The 6th Regional Stakeholder Forum

Second Regional Information Sharing on Pak Lay Prior Consultation Process

Second Draft Technical Review on Navigation

Ms. Thi Thanh Yen Ton Nu, Navigation Operation Specialist, MRC Secretariat

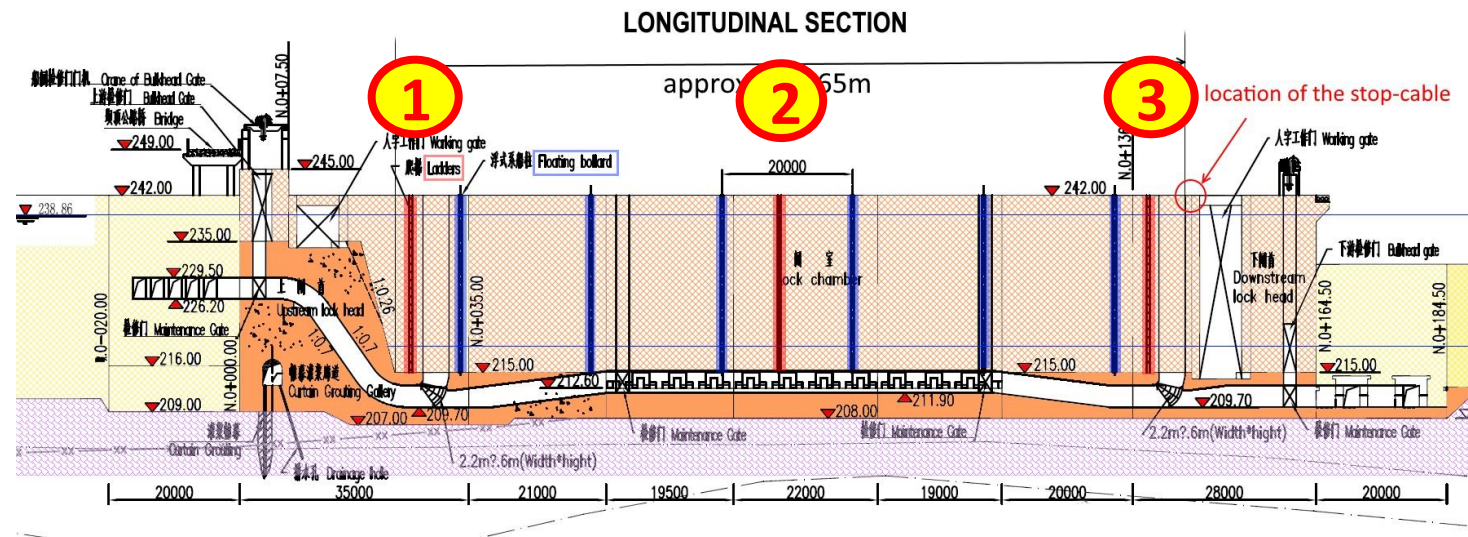
- Three ladders per lock chamber wall are not enough;
- “Six floating bollards are distributed along the lock chamber...”, hence totalling 12 over the entire lock chamber. In order to be consistent with Xayaburi: 2 x 5 floating bollards per lock chamber wall would be enough;

LONGITUDINAL SECTION

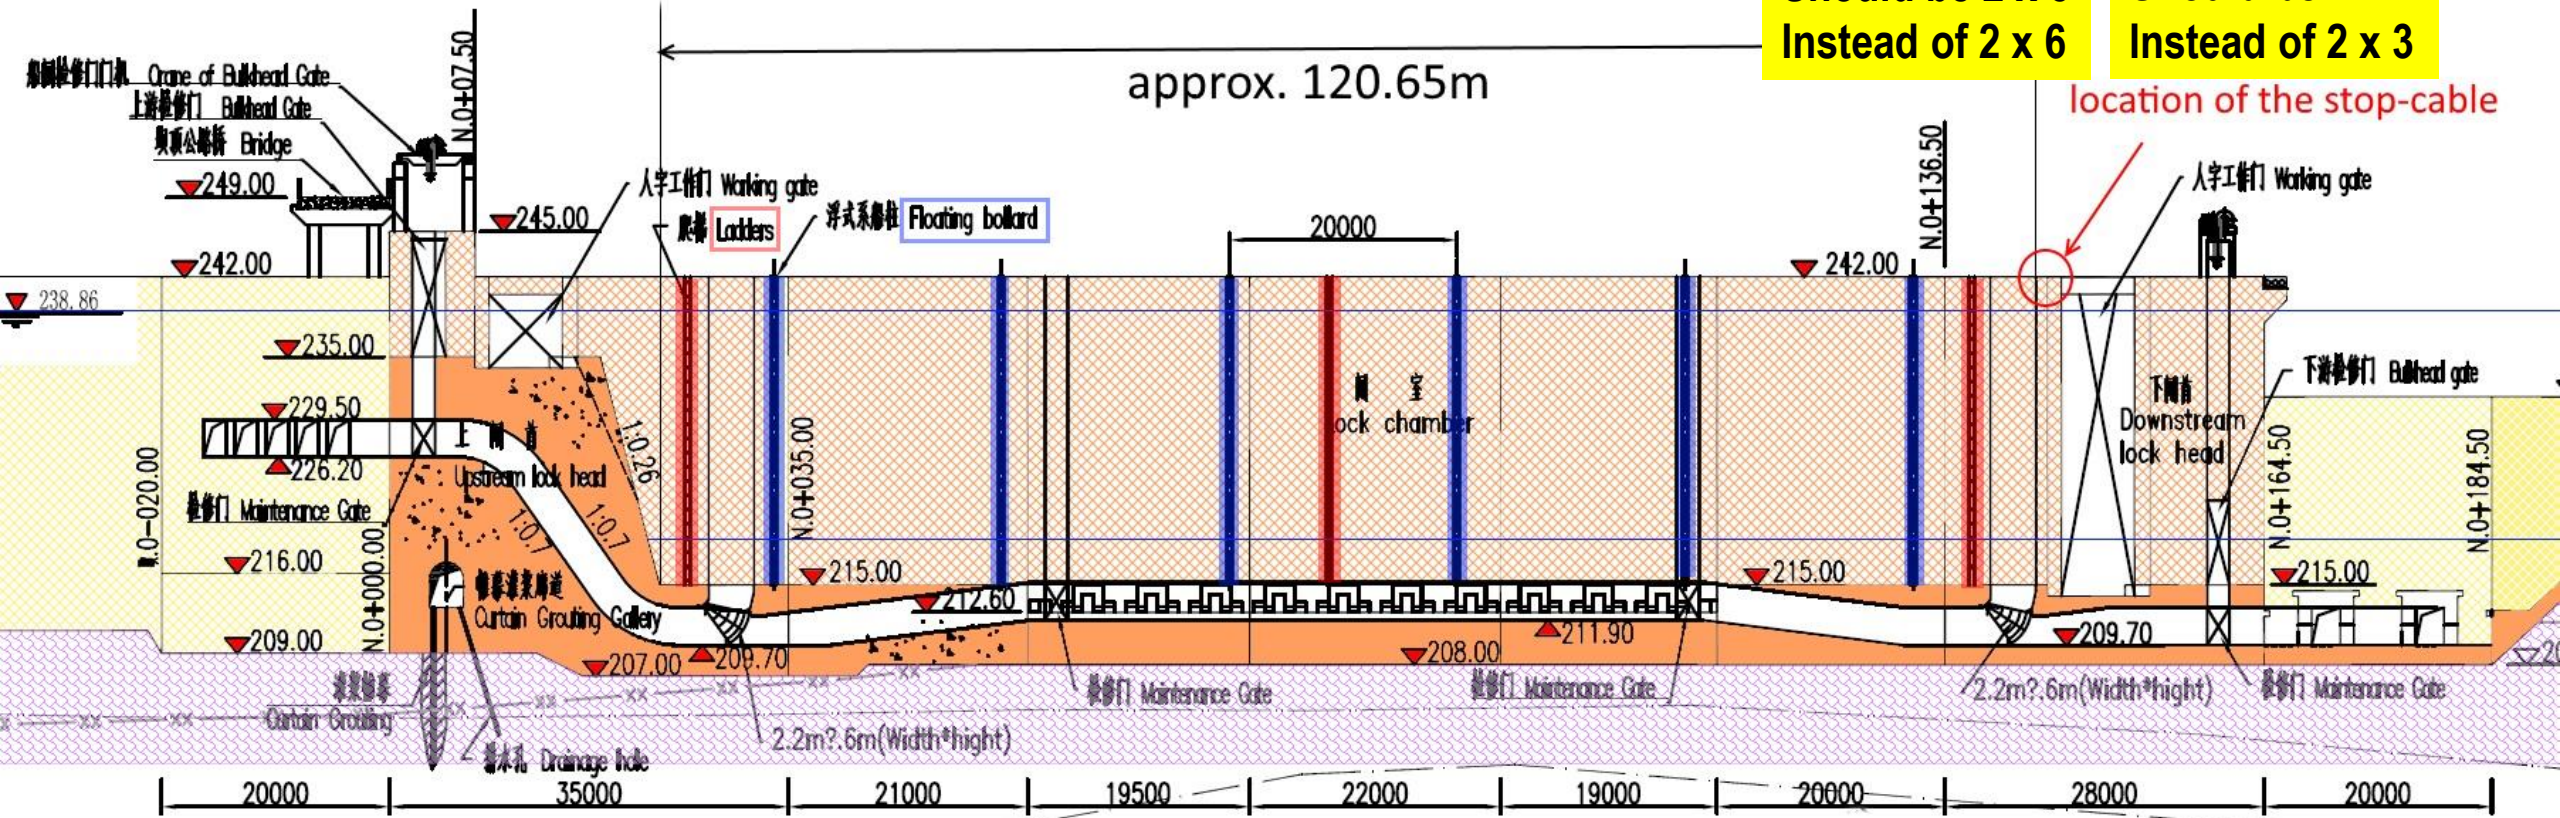
Should be 2 x 5
Instead of 2 x 6

Should be 2 x 4
Instead of 2 x 3

1. Increase the height of the bridge over the upper lock head and the rolling crane (minimum 10.00m);
2. Adapt ladders and floating bollard; provide enough space for stoppage cable;
3. Clearly define the area for the second ship lock including its approaches;
4. Improve (dredge?) and provide Nav aids to the upstream navigation channel which has to cross in front of the powerhouse and spillway;

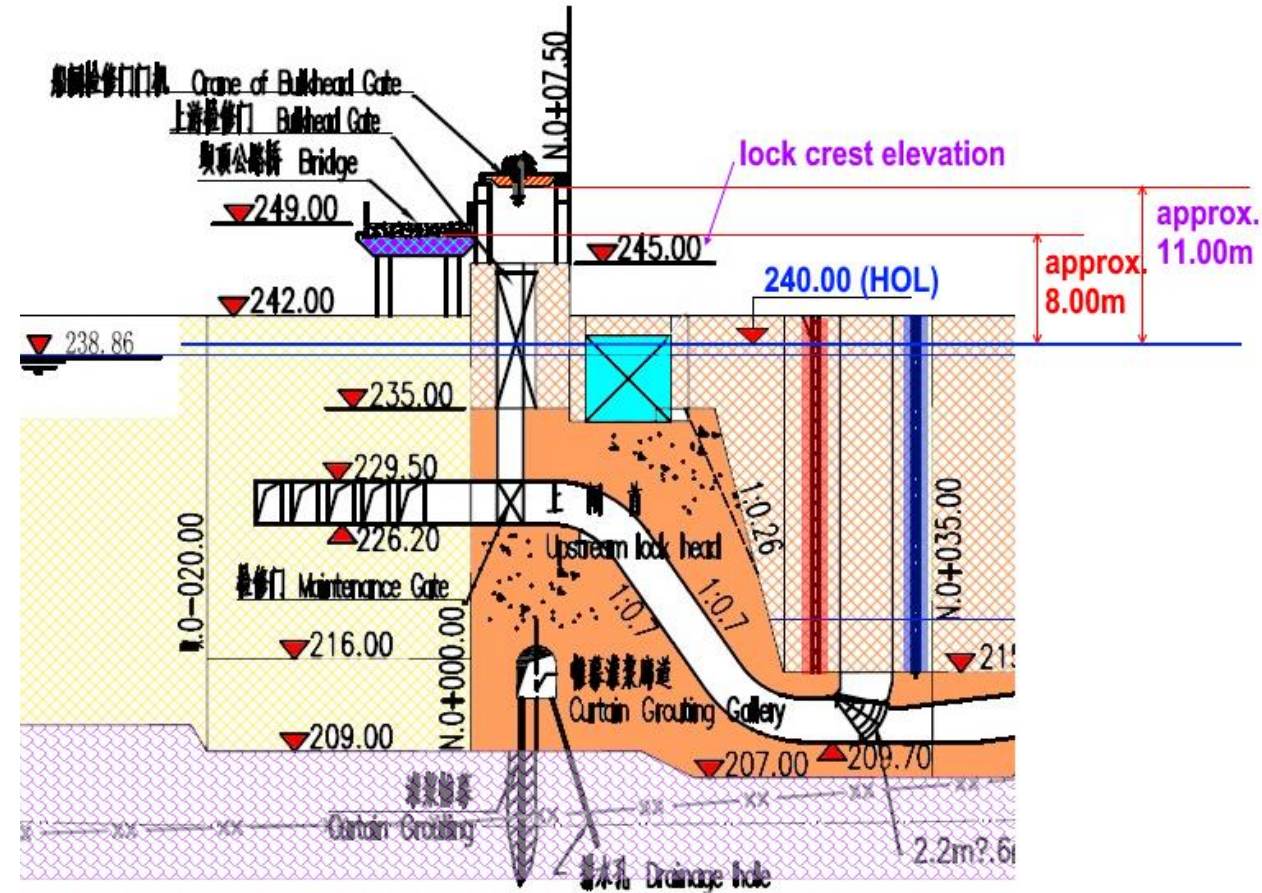
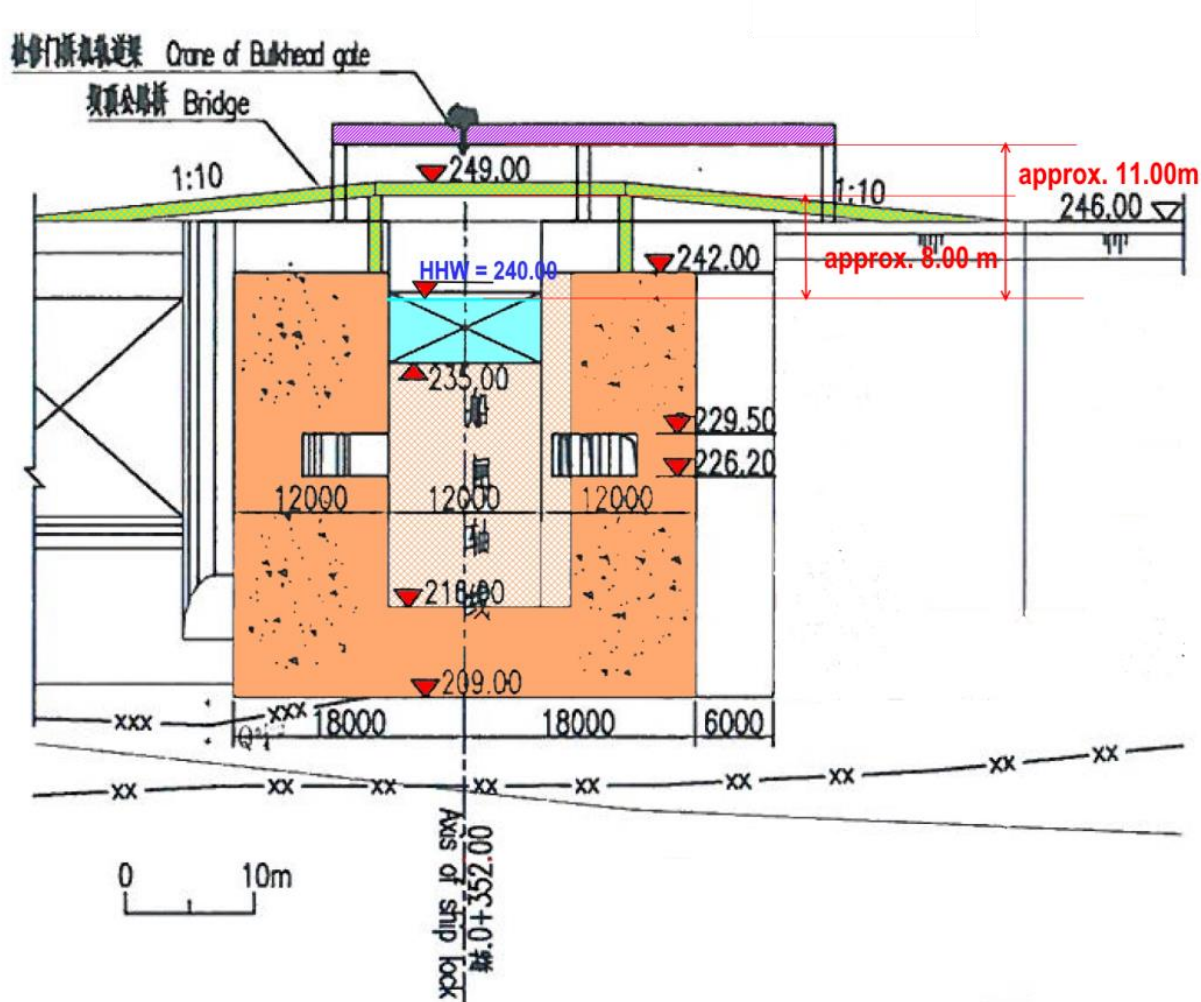
- Low bridge over the upper lockhead, only 8.00 meters air clearance. The usual air clearance under the bridges is 10.00 meters by highest high water level;
- The available place to lodge the mechanism for the stop cables upstream the downstream miter gate is questionable. The stop-cable mechanism is to be explained in more detail.

Line hooks at various levels inside the lock chamber

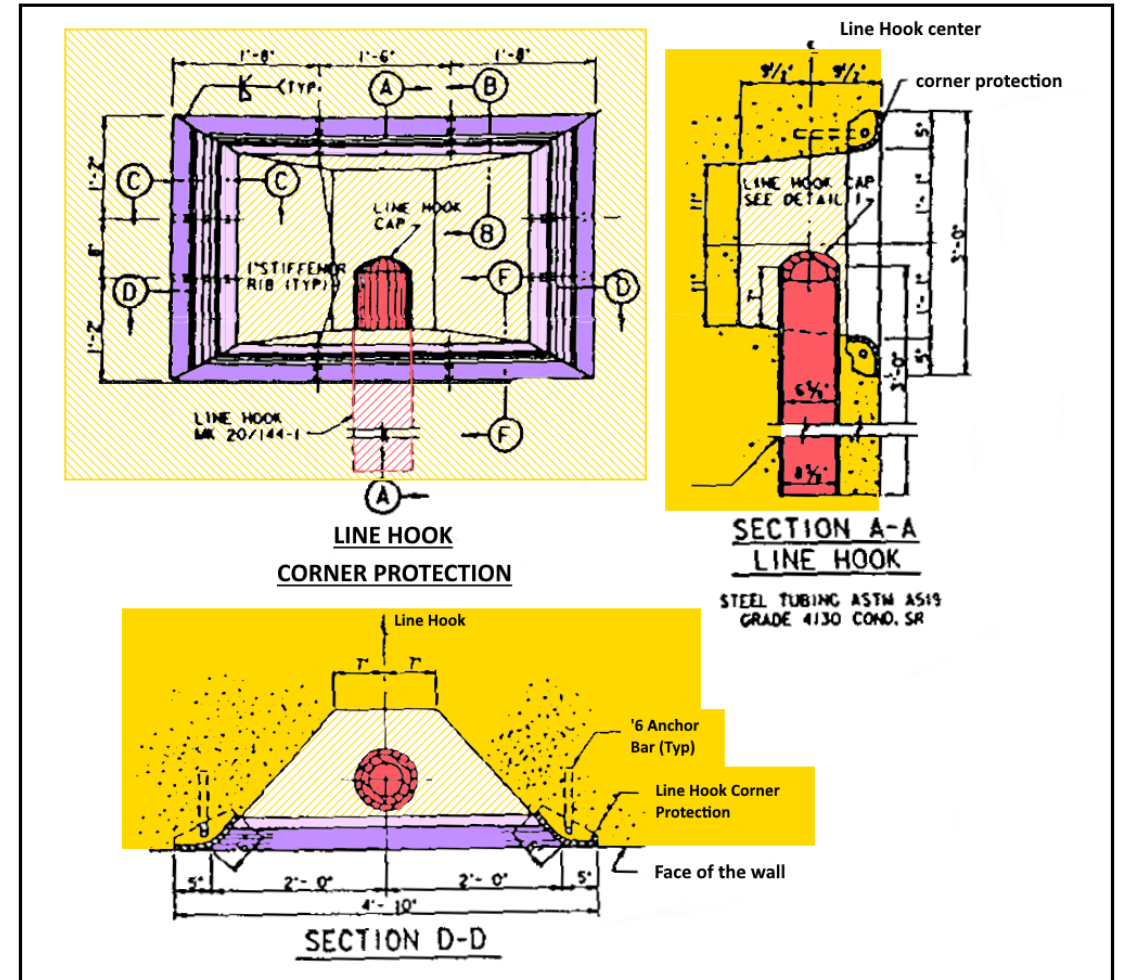
- There should be line hooks in the lock chamber and the guidance walls at various levels, adjacent to the ladders;
- At least one additional ladder in the upper and lower guidance walls outside the chamber are recommended.

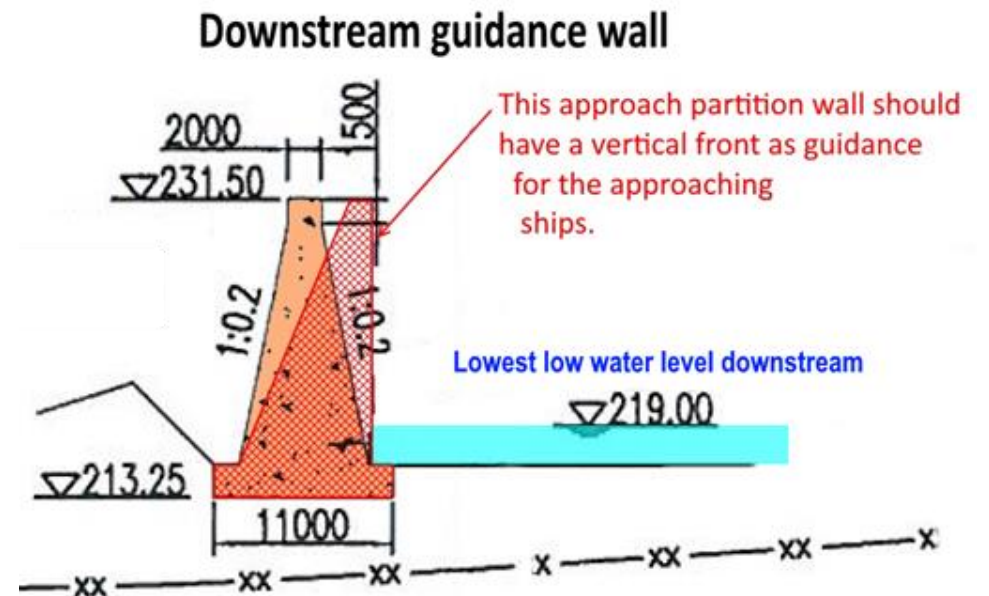
- The ship lock is situated at the right river bank, which is a shallow area of the river. The current navigation channel is on left
- The area for the second ship lock and its axis has not been clearly defined and is not shown on the drawing
- No clear plan or drawing indicating the actual and future the ship-lock
- The downstream guidance wall doesn't have a vertical front as is the case with the upstream guidance wall

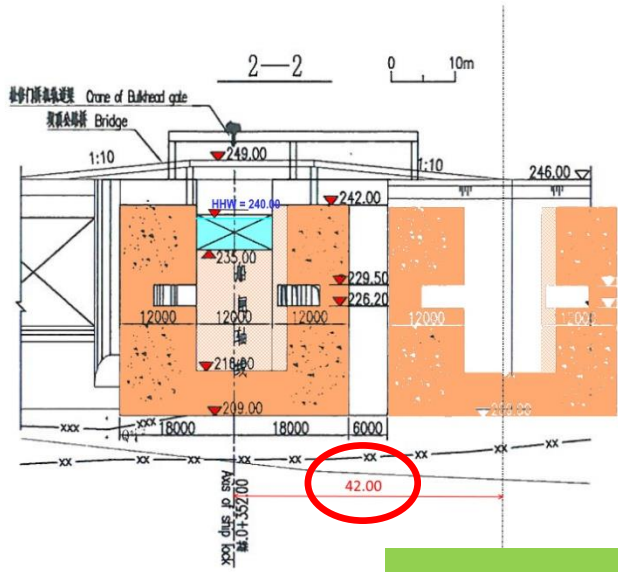
Developer's situation plan superposed on the Google Earth picture, showing the new navigation channel will be over a very substantial length in shallow area (dry rocky land during low water season)

SECOND SHIP LOCK ALIGNMENT AT RIGHT BANK

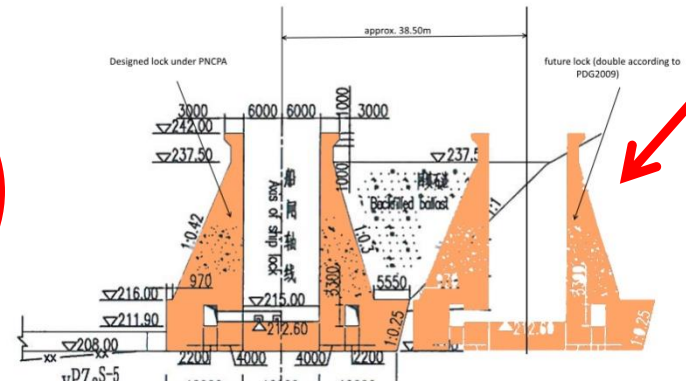
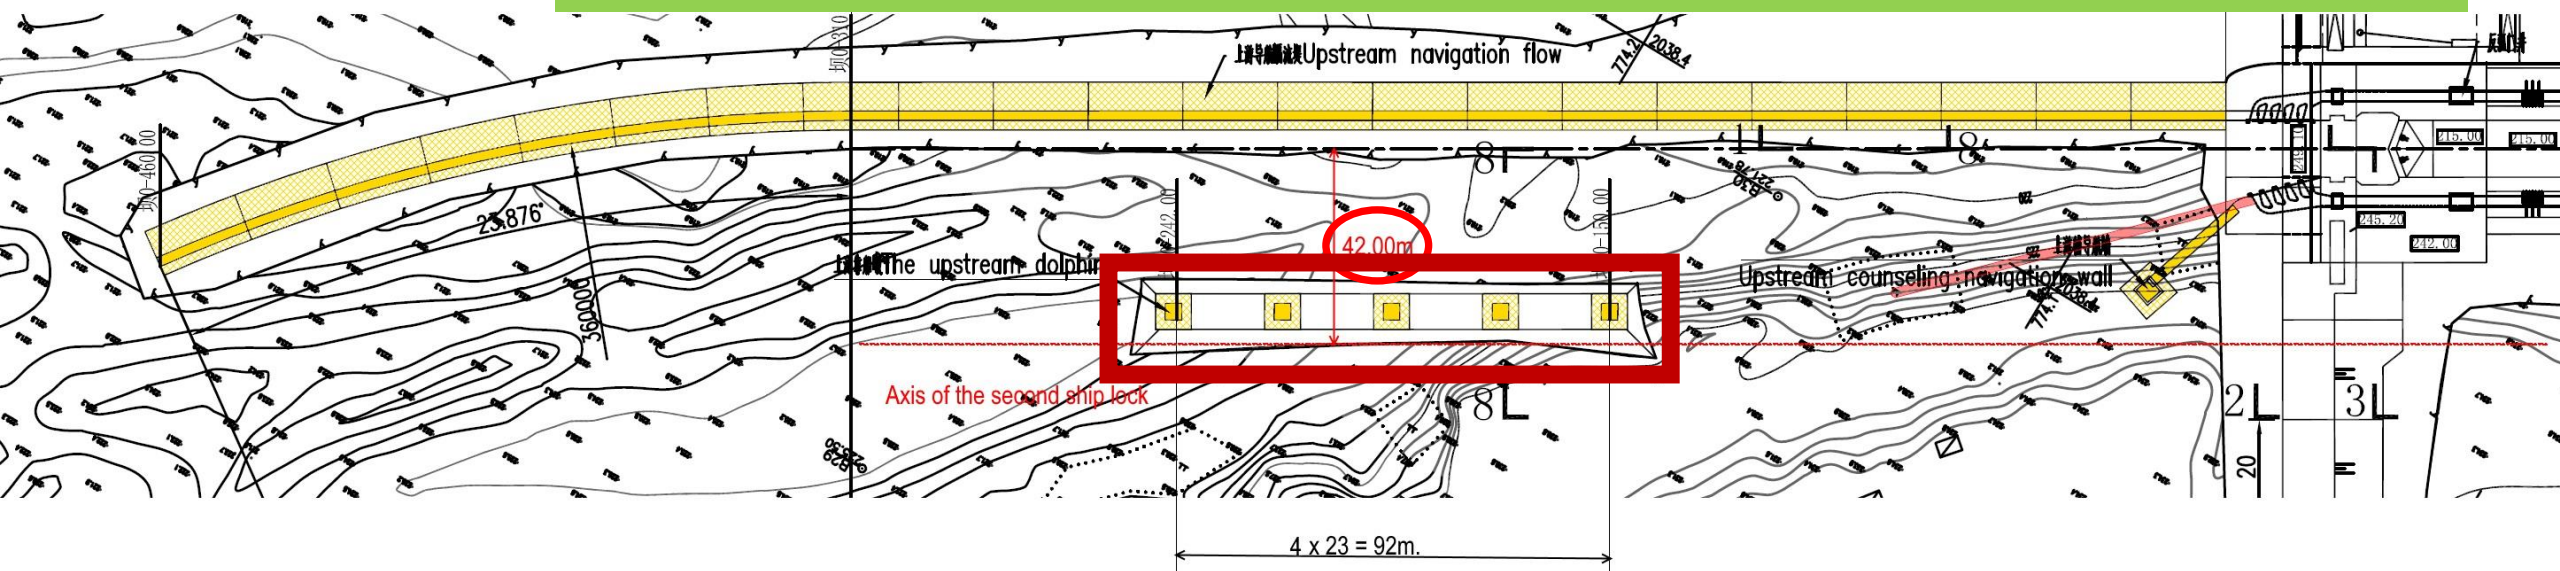
Second lock!

Future lock (PDG2009)

OBSTRUCTING THE APPROACH TO THE FUTURE SECOND SHIP LOCK!!!

5. Reconsider the locations of the 5 dolphins up- and downstream that will hinder the entrance to the future second ship lock;
6. The downstream guidance wall should have a vertical front;
7. Redesign the downstream navigation channel including additional excavation works to accommodate future second shiplock access;
8. Road connections to all parts of the ship lock, also to the downstream lock head.
